## Fresenius Medical Care North America Service Bulletin

Equipment: 2008T Hemodialysis Machines  
 Bulletin: 12-FRT-004 Rev A  
 Subject: UI-MICS Board Touchpad Reset Board Requirement

Below are pictures showing the different orientation of the Touchpad connector and the different connector designation:

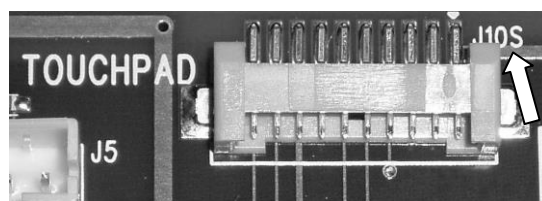
- Boards with a Touchpad connector **J10** require a Touchpad Reset board to be installed in connector J9.
- Boards with a Touchpad connector **J10S** has the Touchpad Reset circuitry integrated into the UI-MICS board and does not require a separate Touchpad Reset board to be installed.

Requires Touchpad Reset Board

Does not require Touchpad Reset Board
